DISCOVERY BAY WOMEN'S CLUB

ENGINEERING EVALUATION

LARGE ON-SITE SEWAGE SYSTEM (LOSS)
(LOSS System I.D. No. JEF002)

August 22nd, 2025

Sheet OS2.05 – Detail No. 3 – Typical Dripfield Layout:

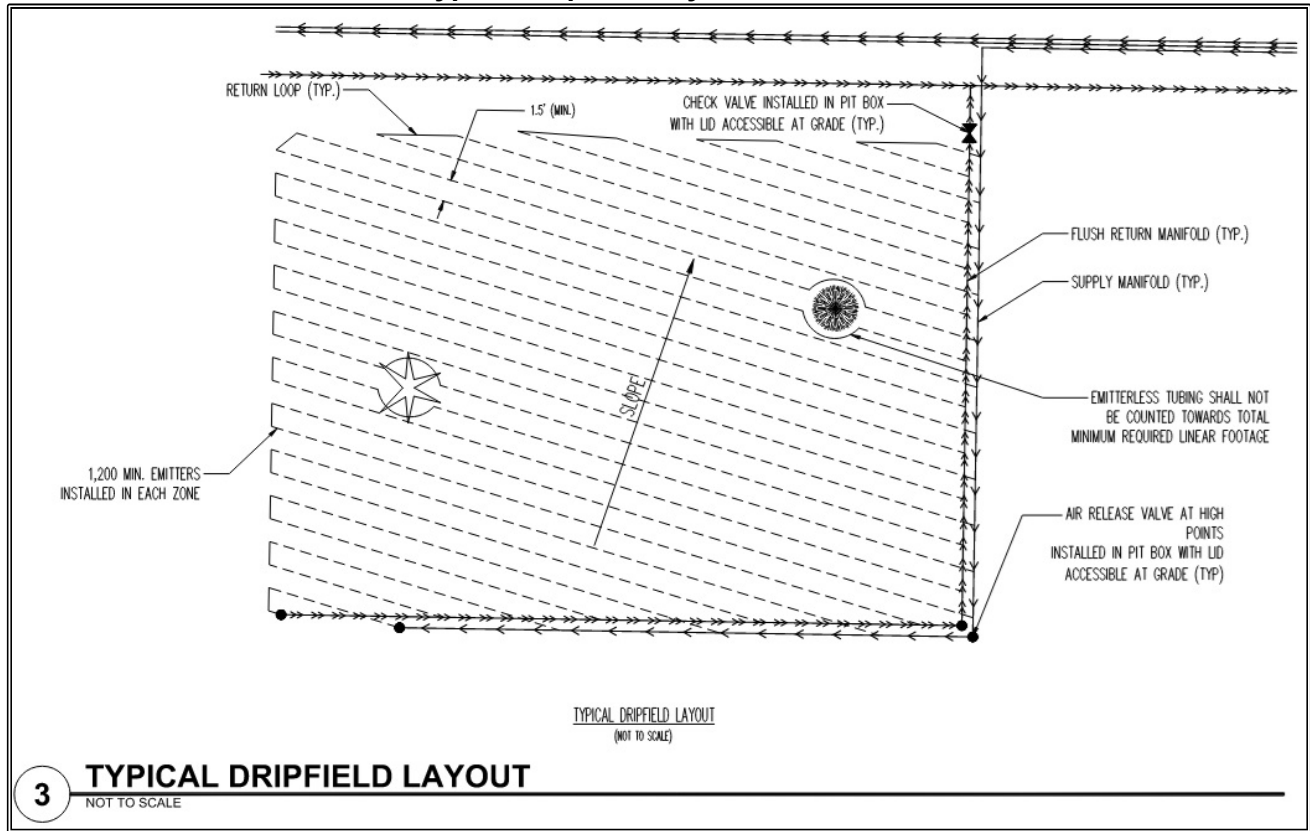
This detail has long zone Supply and Return Manifolds running up the slope from bottom to top of the zone. Another detail – Detail #2 on Sheet OS2.04 – shows both the Supply and Return Manifold size as 2"Ø. Without Supply Manifold check valves between every dripline lateral, or every few dripline laterals, and without dripline lateral check valves at the ends of the laterals just before they connect to the Return Manifold, the entire dripfield zone will drain down to the bottom of the zone after the pump shuts off, causing low-end overloading, or low-end drainage. In addition, when the pump starts pumping, the zone fills from the bottom up, so the lowest laterals are being filled (and dosing) first.

During the May 27th, 2025 site visit, it was observed that the bottom 1/3 of Zones 4, 5, and 6 were the areas that were failing. There was no failure (ground saturation or ponding) within the top 2/3s of those zones. **The failure is clearly primarily from low-end overloading.**

The preferred layout method on sloped sites is to use short top-end, or high-end, manifolds, which significantly minimizes any draindown, and also distributes effluent into the driplines more evenly. It also does not require any manifold and dripline lateral check valves (i.e. much more O&M friendly).

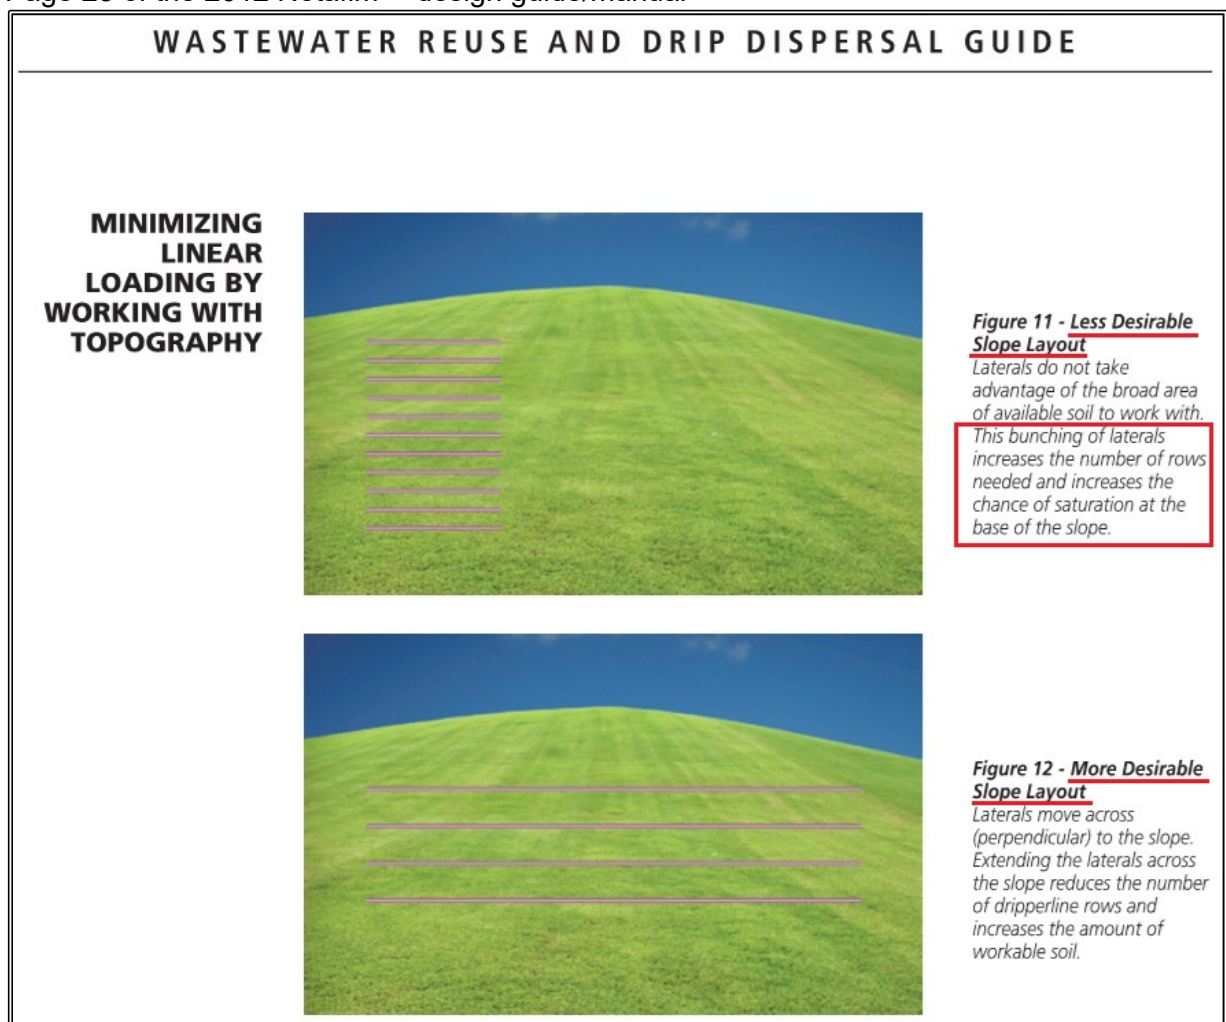
Other design issues were noted in the LOSS Repair Record Drawings. Detail #1 on Sheet OS2.04 shows a typical dripline trench:

The Netafim™ Bioline Dripline has an outside diameter of almost $\frac{3}{4}$ ". With the detail above, this would mean that the cover over the top of the dripline would only be 5-1/4" to 7-1/4". This is shallower cover than the minimum dripline cover requirements as specified in WAC 246-272B (LOSS Code) and shallower than what is typically recommended.

During the May 27th, 2025 site visit, Aqueous discovered a failed area of dripline that had a small section of dripline with only 1-1/2 inches of cover, while other sections nearby had 6" to more than 8" of cover (but were still failing). Inadequate cover will also allow effluent to surface, however these failure spots would generally be localized. Regardless, based on the Jefferson County lowland frost depth of 12 inches, requirements and recommendations in WAC 246-272B and the NetafimTM design manual, the driplines should have been designed with a minimum of 8 inches of cover, with a preferred cover of 12 inches based on frost depth.

Aqueous has always interpreted this requirement to mean that the top of the dripline must have a minimum depth of cover of eight inches.

Sheet OS1.02 shows narrower zone layouts relative to contour layout for Zones 4, 5, & 6:

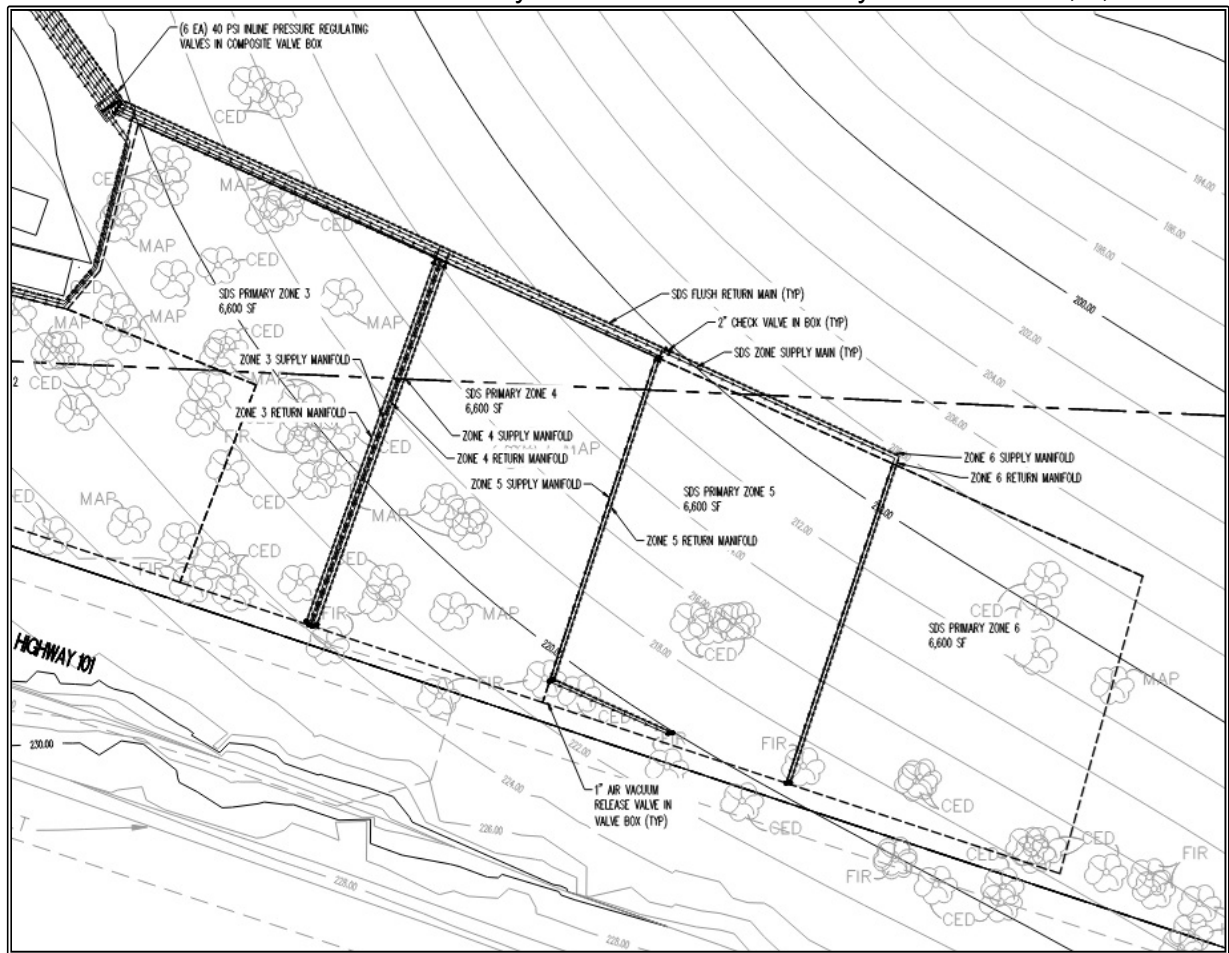
The design layout of Zones 4, 5, 6, and a portion of Zone 3, as shown on Sheet OS1.02 of the LOSS Repair Record Drawings, has the zone configuration narrower down the slope, requiring many more rows of dripline laterals:

As stated in the Netafim™ design manual, “The bunching of laterals increases the number of rows needed and increases the chance of saturation at the base of the slope.”

This could also be contributing to the drainfield failure of these three zones.
